**STAFF RECOMMENDATION
138 Blackburn Avenue
October 21, 2020**

Application: New Construction- Outbuilding
District: Belle Meade Links Triangle Neighborhood Conservation Zoning Overlay
Council District: 23
Base Zoning: RS10
Map and Parcel Number: 130010159
Applicant: Tim Vermeer
Project Lead: Jenny Warren, jenny.warren@nashville.gov

<p>Description of Project: New Construction of an outbuilding, including a dormer with a one foot (1') inset.</p> <p>Recommendation Summary: Staff recommends approval with the following conditions:</p> <ol style="list-style-type: none"> 1. Staff shall approve the final roof color, masonry, windows, doors and garage doors prior to purchase and installation; 2. The maximum siding exposure shall be five inches (5"); 3. Revised elevations shall be submitted, prior to permitting, indicating a one foot (1') inset for the dormer on both the east and west: and 4. Revised elevations shall be submitted, prior to permitting, indicating a maximum average eave height of ten feet (10') and a maximum ridge height of approximately twenty feet (20'); <p>finding that the project meets II.B of the Belle Meade Links Triangle: Handbook and Design Guidelines.</p>	<p>Attachm

Figure 3: Front-facing/East elevation

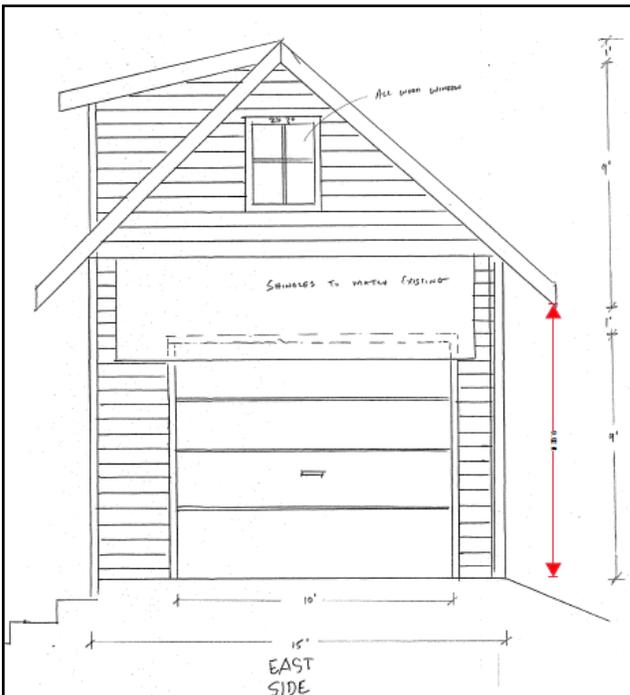
On the front, east-facing elevation, the ridge and eave heights meet the requirements for height at twenty feet (20') and ten feet (10') from grade, respectively. (Figure 3)

Figure 4: Proposed west elevation. The green line indicates approximate grade.

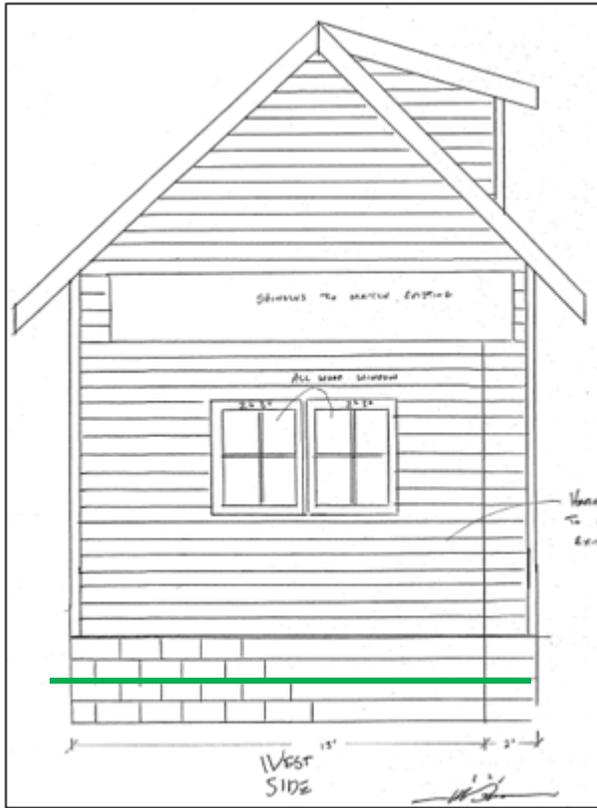
The grade is unclear on the remainder of the drawings – it has been cut away in section a bit on the rear/west elevation, resulting in several more rows of block showing than will be visible. (Figure 4)

is only inset one foot (1') instead of the required two feet (2') from the wall below. (The inset is showing on the west elevation, but not the east. The applicant has stated that they intend to inset the dormer one foot (1').) Staff finds that the smaller inset could be appropriate in this instance. Because the footprint of the outbuilding is so small, requiring a two foot (2') inset would severely limit the available second level square footage and perhaps encourage an increase in the ground level square footage. Also, the dormer faces the interior of the lot and will not be visible from public rights-of-way. Staff recommends that the applicant submit revised drawings for the east and west elevations, clearly indicating the one foot (1') inset for the dormer. With this condition, staff finds that the proposal could meet Section III.B.2.h.1 of the design guidelines for roof shape.

Staff recommends that revised drawings are submitted, showing accurate post-construction grade. There should be a maximum average eave height of ten feet (10') and a maximum ridge height of approximately twenty feet (20'). With this condition, Staff finds that the proposal meets Section III.B.2.h.1 of the design guidelines.

1. Staff shall approve the final roof color, masonry, windows, doors and garage doors prior to purchase and installation;
2. The maximum siding exposure shall be five inches (5");
3. Revised elevations shall be submitted, prior to permitting, indicating a one foot (1') inset for the dormer on both the east and west: and,
4. Revised elevations shall be submitted, prior to permitting, indicating a maximum average eave height of ten feet (10') and maximum ridge height of approximately twenty feet (20');

Figure 5: South elevation. Dormer size is appropriate (note that there are not exterior stairs, this drawing is showing a partial section). The green line indicates approximate grade.

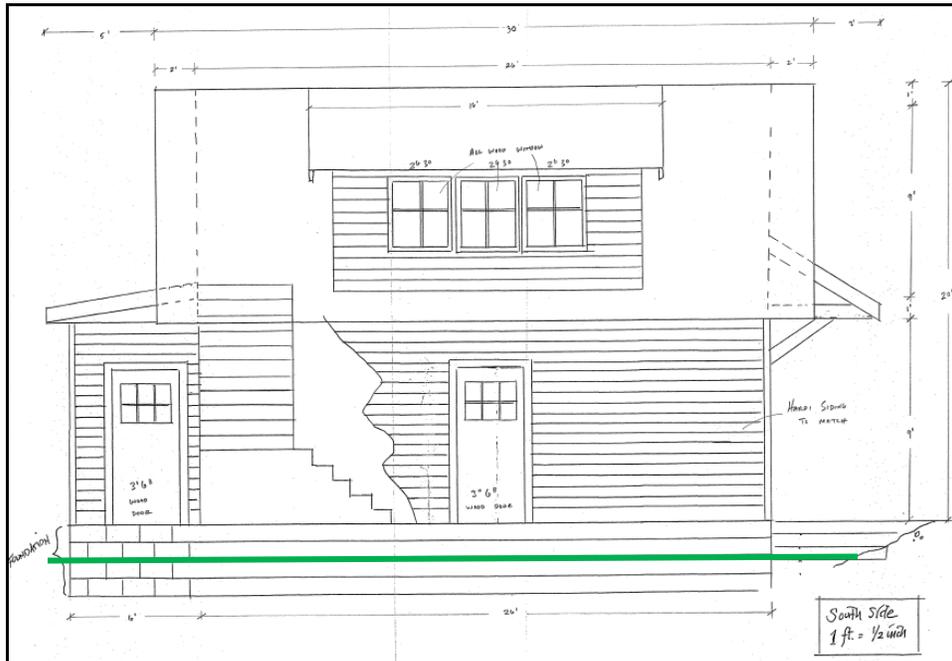
The primary roof form is gabled, which is appropriate. A shed dormer on the south side elevation occupies less than fifty percent 50% of the wall plane. (Figure 5) This dormer
